2007 CORRIDOR BASELINE DEFINITION OF THE REFERENTIAL

Project:	ERTMS
Document type:	Engineering

Issue date:	26 th May 2006
Doc. Nr :	05-1E142-PEEE
Version :	2a

3.5 CR U170 “INDICATION OF TRACK CONDITIONS”

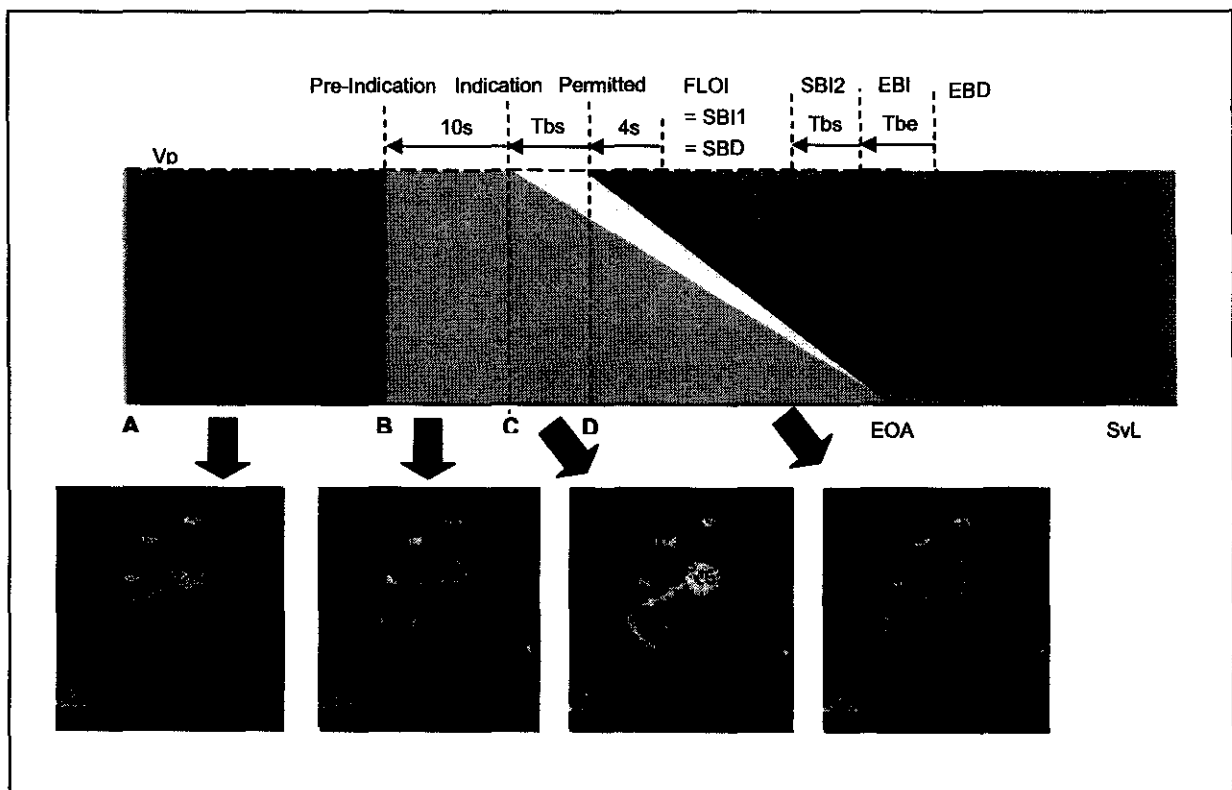
The operational scenario describing the indication on DMI of track conditions is attached in annex 2 of this document. This scenario defines an announcement distance between the announcement location (point B) and the execution location (point D). This distance needs to be long enough to ensure that the driver (or an optional automatic system) is able to reduce the traction power, open the main switch and lower the pantograph before reaching the beginning of the neutral section.

The requirement for the Corridor 2007 infrastructures is that the announcement distance (B-D) shall be based on a minimum time of 17 seconds, taking the actual line speed into account. The trains must respect this requirement and must be able to manage in less than 17 seconds the onboard functionality.

Figure 1 Passing a neutral section

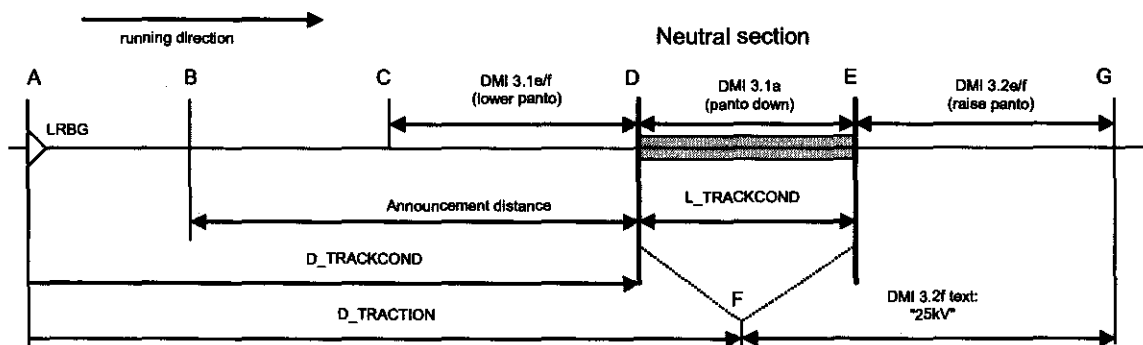
The operational scenario is given in figure 1 for a level 2 situation. For level 1 it is the same except where mentioned in the description.
